Seismic Walkdown Checklist (SWC)

Equipment ID No. 1-1605-C5-AS1 Equip. Class¹² 20 (INSTRUMENT & CONTROL PANEL)

Equipment Description EAGLE 21 DUAL COMPARTMENT SEISMIC CABINET

Location: Bldg. CONTROL Floor El. 240' Room, Area R 267^{11/14/12} R 230

Equipment ID No. 1-1605-PS-SDB Equip. Class¹² 20

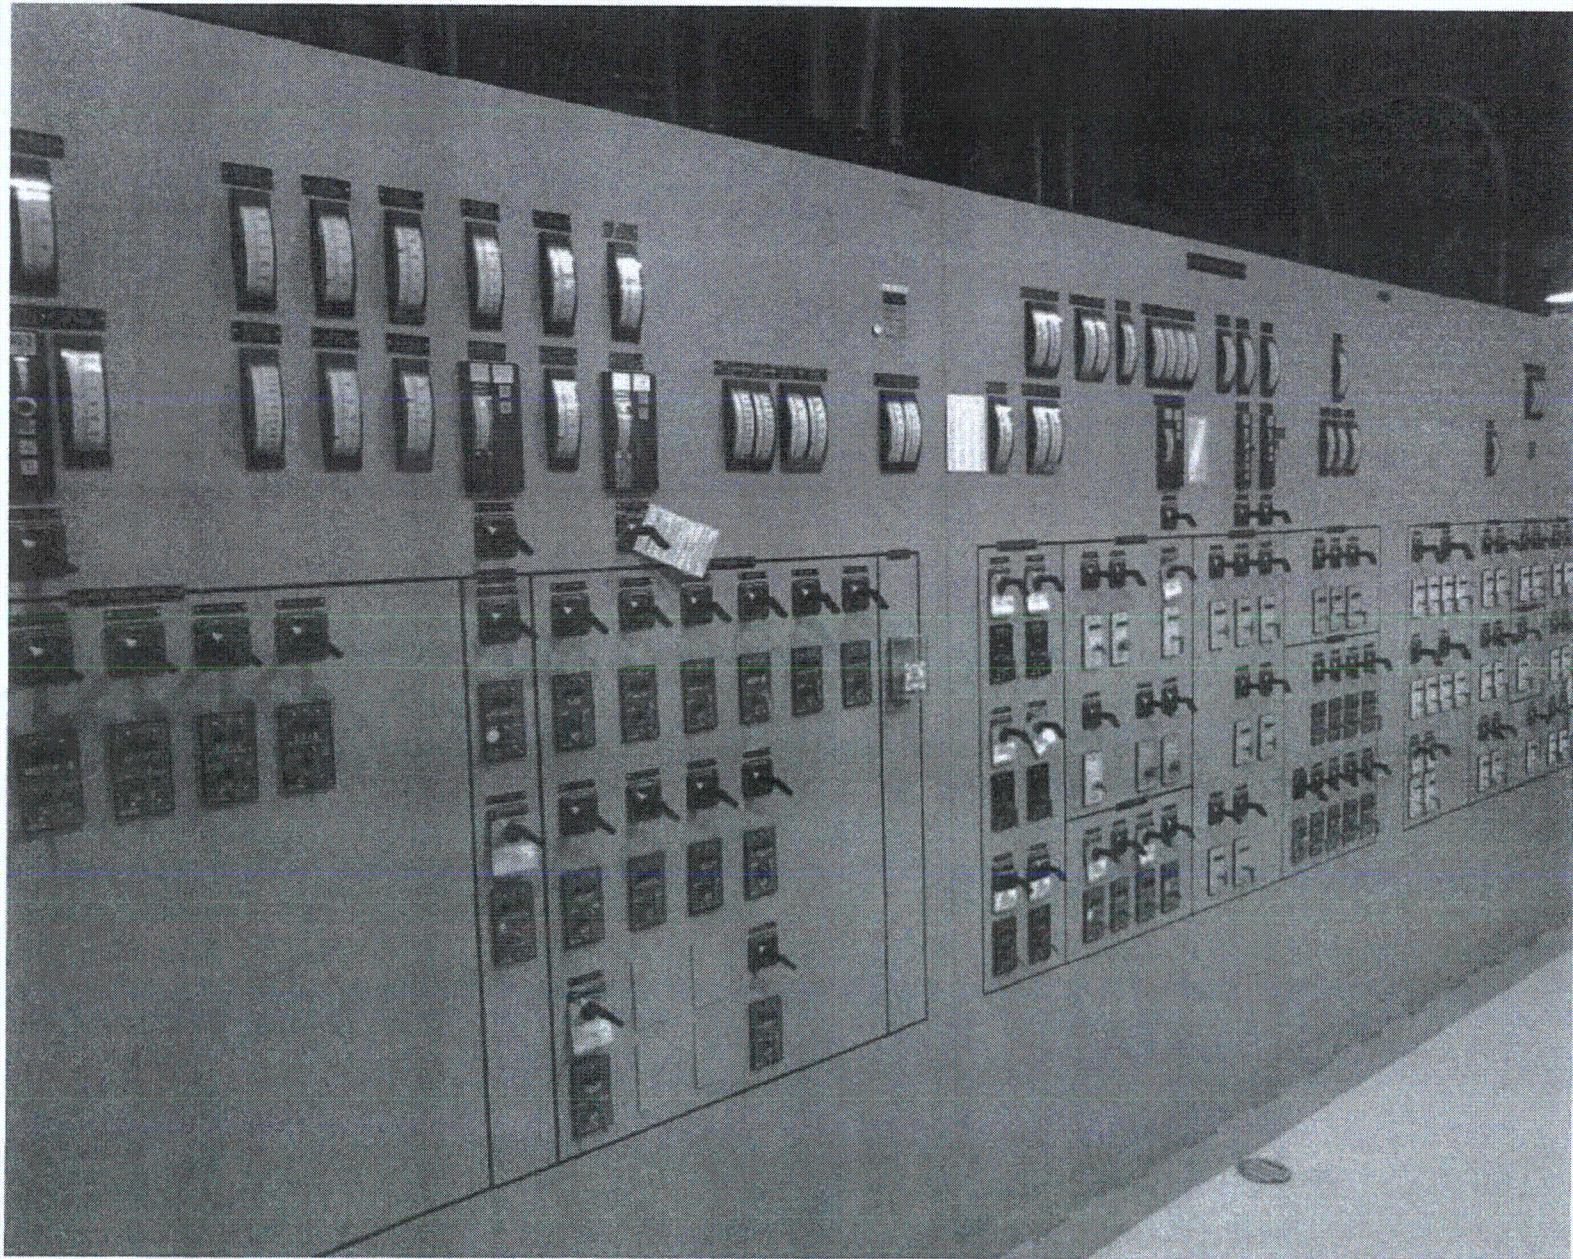
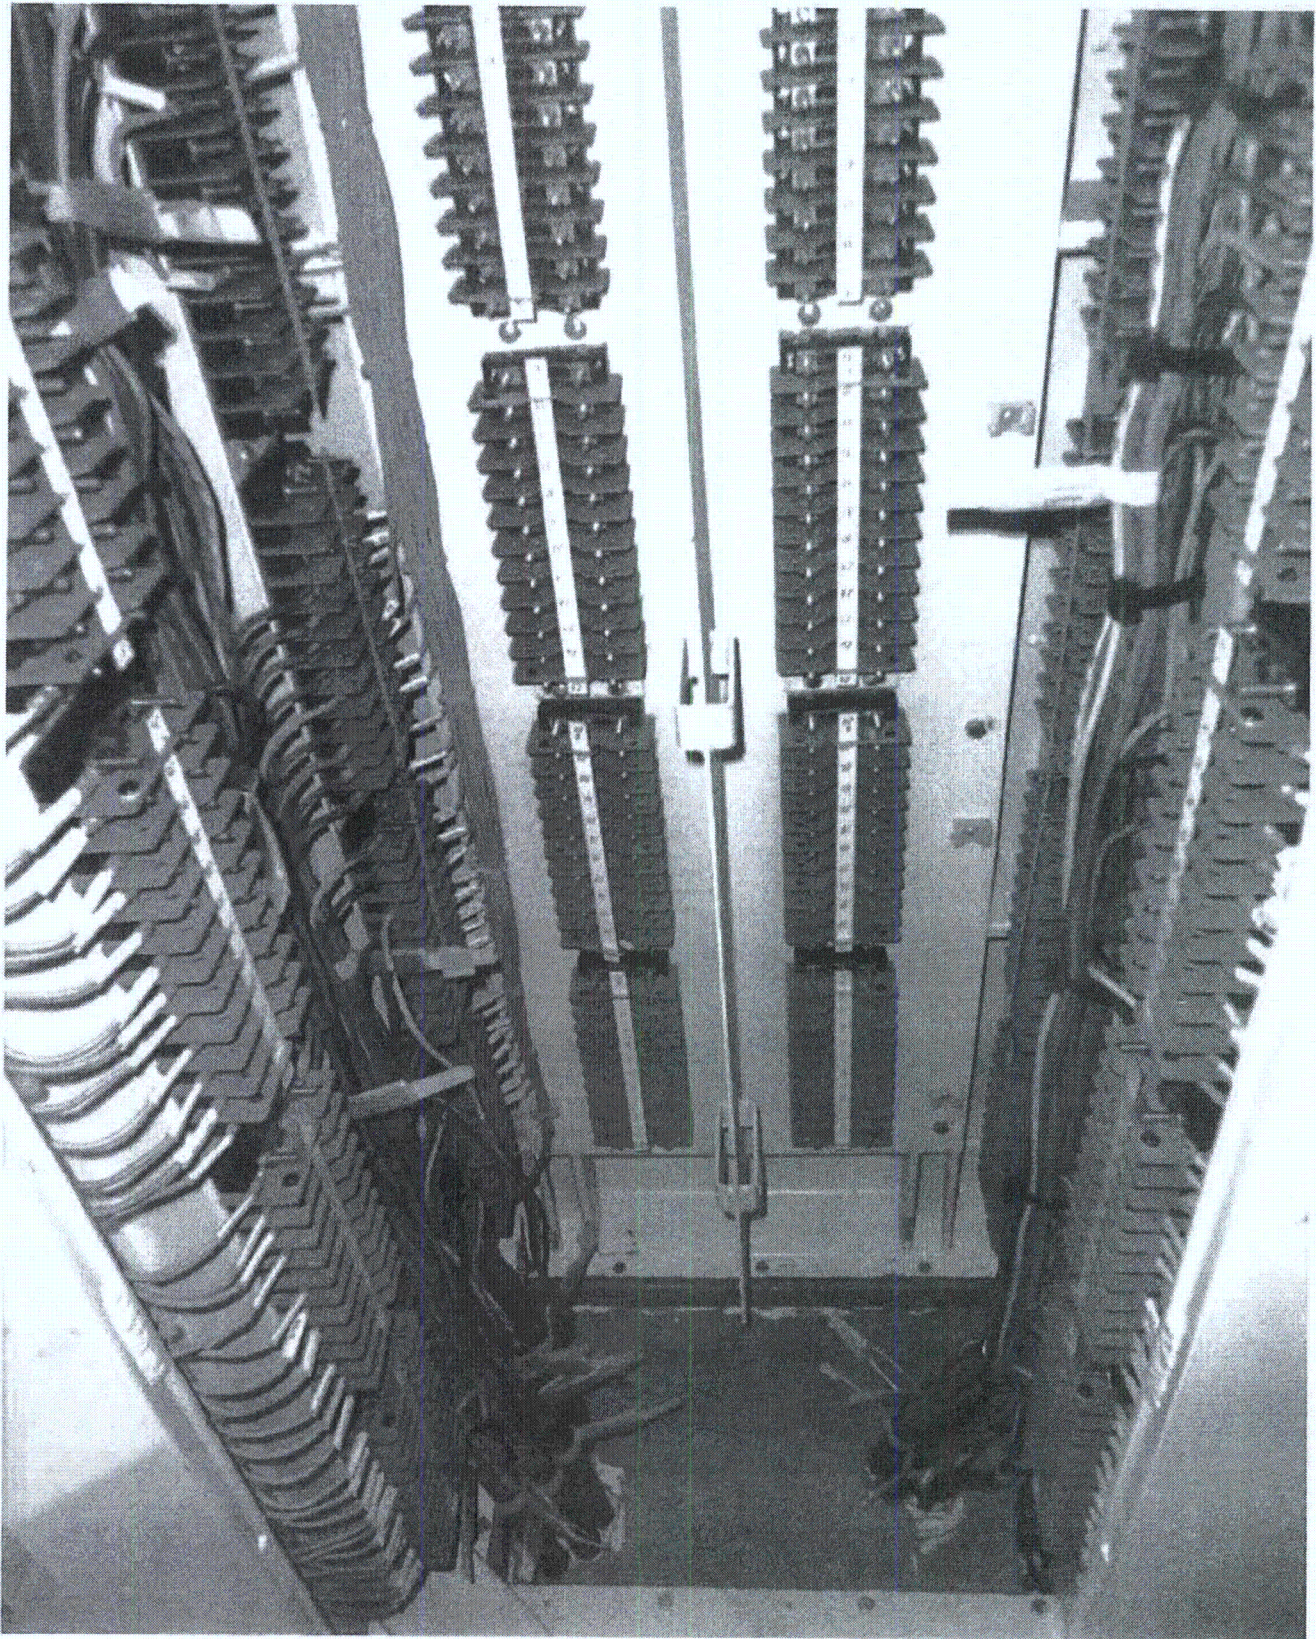
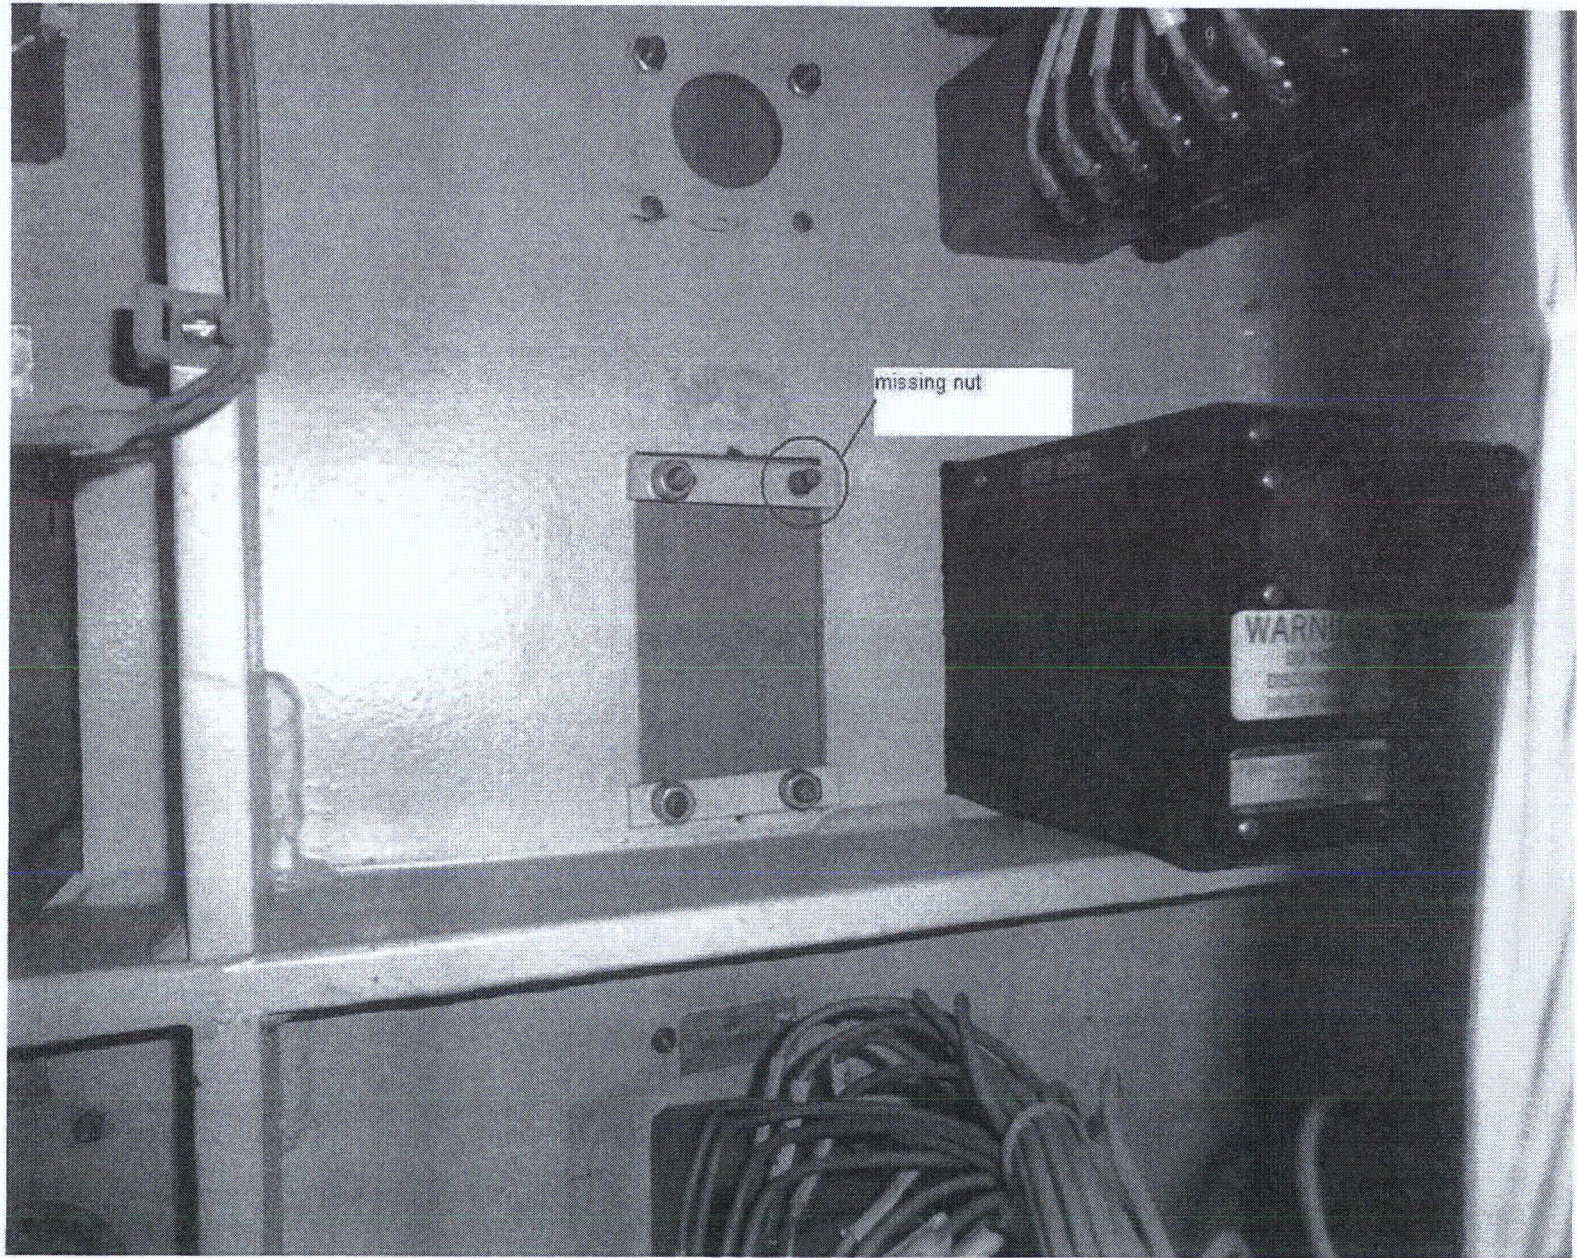
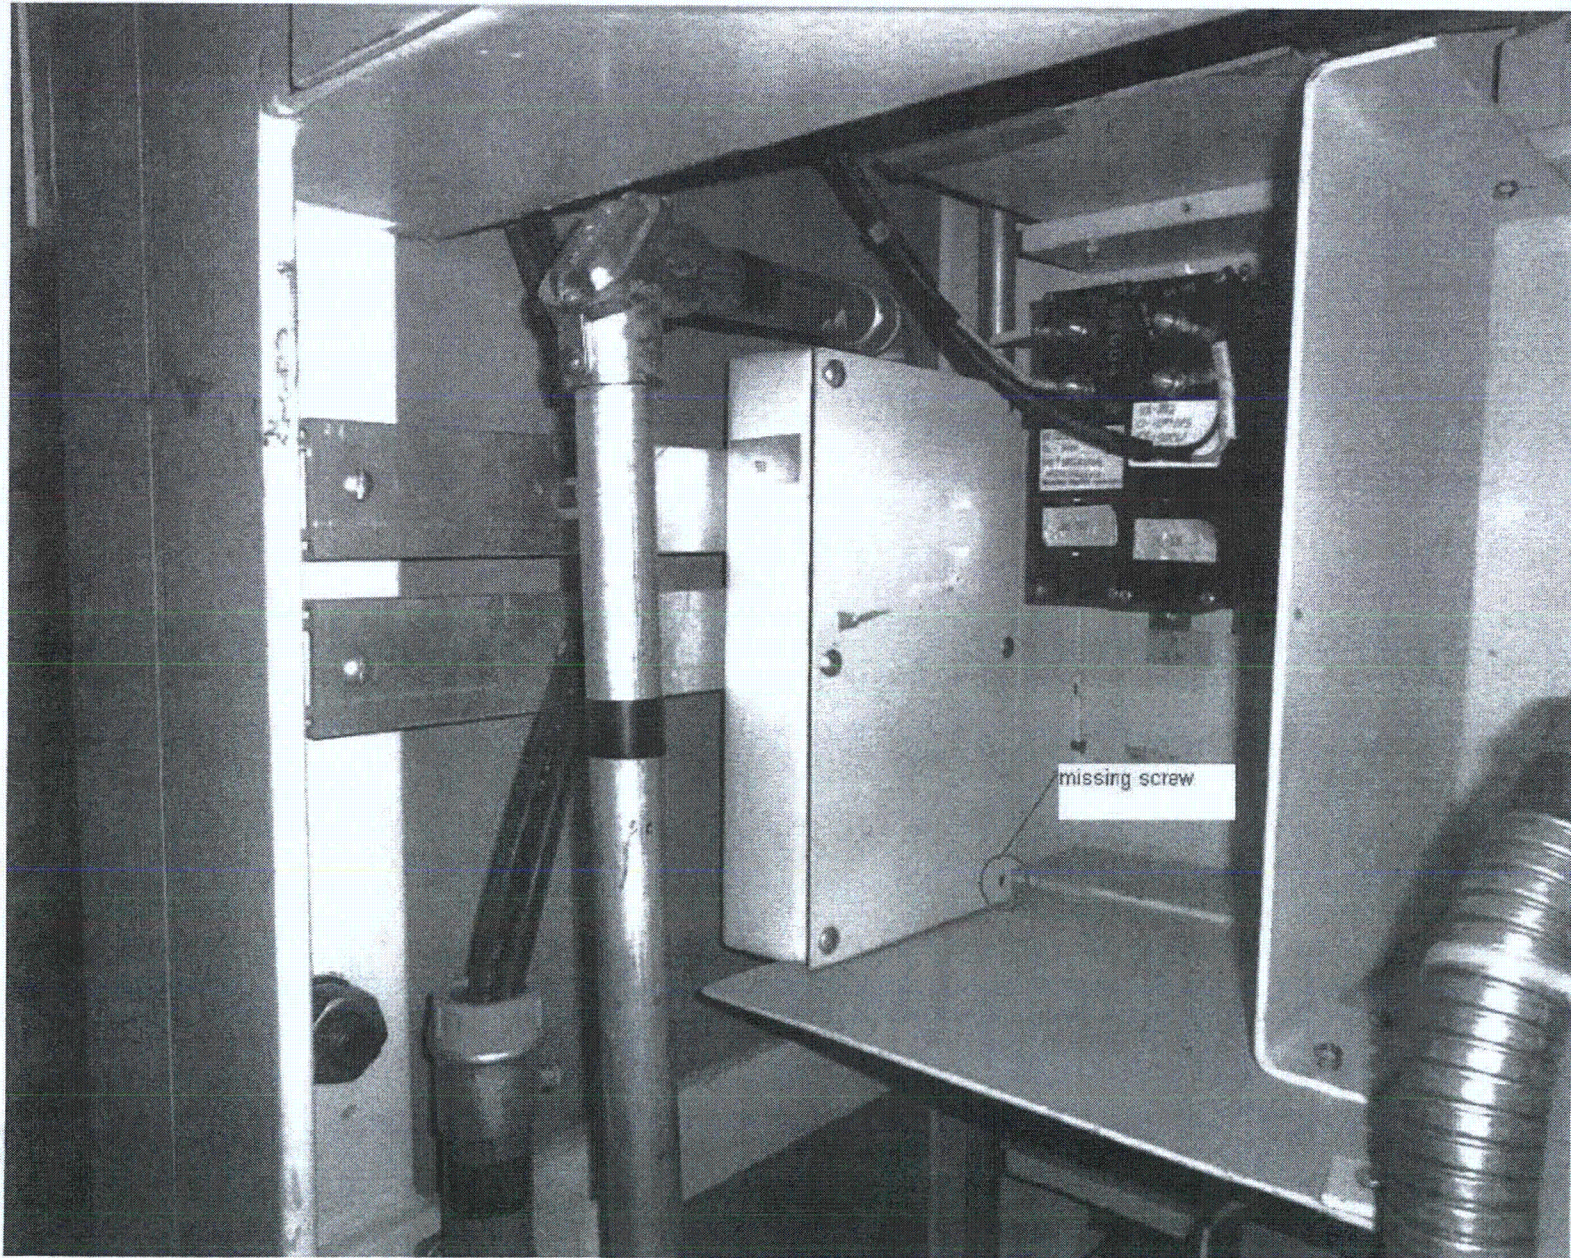
A VISUAL INSPECTION OF THE INTERNAL COMPONENTS OF THIS CABINET WAS PERFORMED TO CHECK FOR SEISMIC ADEQUACY TO INCLUDE ANY EVIDENCE OF INTERNAL COMPONENTS NOT ADEQUATELY SECURED, CHECKED TO ENSURE FASTENERS CONNECTING ADJACENT CABINETS WERE IN PLACE, AND EVIDENCE OF OTHER SEISMIC CONDITIONS. NO SIGNIFICANT ADVERSE CONDITIONS WERE FOUND. SOME MINOR ISSUES ARE DOCUMENTED IN "COMMENTS" SECTION.

MISSING & LOOSE SCREWS, BOLTS, & NUTS ON SOME COVER PLATES & IN A FLOOR PLATE ONE BROKEN RECEPTACLE

THE SEISMIC WALKDOWN TEAM JUDGED THAT THESE CONDITIONS DO NOT REPRESENT A SEISMIC OR OPERABILITY CONCERN FOR THIS COMPONENT

THIS CONDITION HAS BEEN REPORTED THROUGH CR 528400
